Re: ZBA Administrative Changes to prior approved plans for 18 Chestnut St.

REVISION: 11-23-20

PROPOSED ELEVATIONS

OSBORNE RESIDENCE

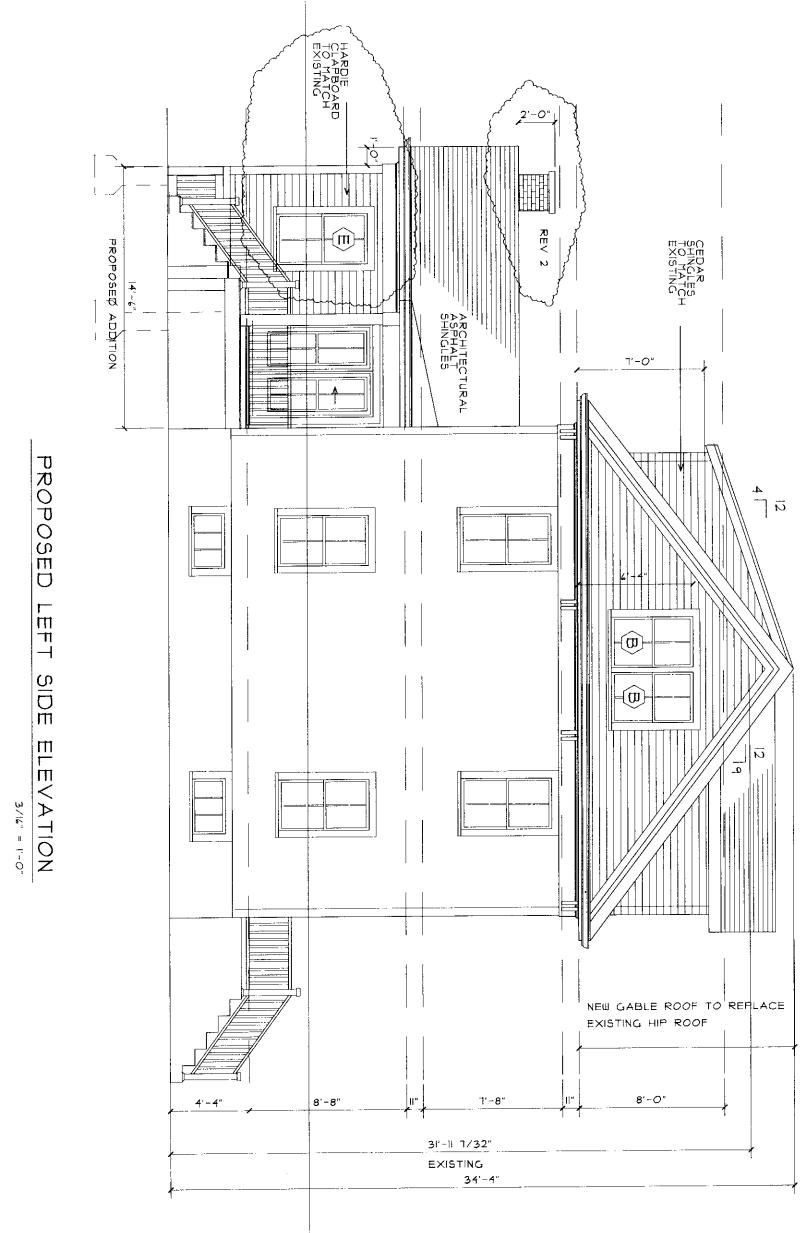
- does require the addition of a chimney stack for venting. The chimney meets the required code of distance and fireplace, ie.. gas or wood burning. We have decided to go with a wood burning option as a prefab firebox, but drawings set which approval was given. The clarification was it was not identified at the time the type of Fireplace - The fireplace as a part of the family room extension was also considered and on the original dimensions from house. See new drawings for added chimney.

- 2 Window Placement – the number of windows and size are the same on the extension. But we have decided to move a window from the right elevation to the left elevation to balance the light in the room.

- ω elevation to bring in more light to the vaulted ceilings in that room. Skylights (2) - We also decided with moving the window to left elevation, to add 2 skylights to the right

- 4 Sliding Door Clarification - On the plans was a French / sliding door. We kept the size of door the same and in same place as the original plans, but in light of the size of the room, chose to do a sliding door over French doors. The original plans may have shown French doors.

- 5 Foundation – In the original drawings we showed a crawl space which has a block base. We decided to do an are still exactly the same as original approved drawings, we just chose piers and a slab vs. blocks. open crawl space and leverage footings. This allows for easier access and storage. The space, dimensions, etc.
